Rezoning Transportation Analysis

Petition Number: 2026-038

General Location Identifier: 06128302

Date	Description
7-30-26	First Review (IW)
9-23-26	Second Review (IW/KC)

6+ Boulevard, Buffered/Separate Bike Lane per Charlotte Streets Map

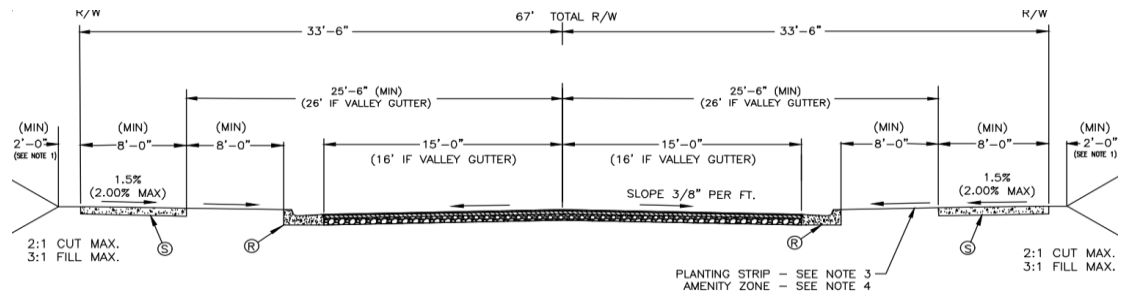
- Little Rock Road/Josh Birmingham Pkwy:** Location of future back of curb and gutter is in it's final location.

Due to conflicts with NCDOT requirements, curb will remain in it's existing location and development will be required to commit to bike facilities by constructing an 8' planting strip and 12' path.
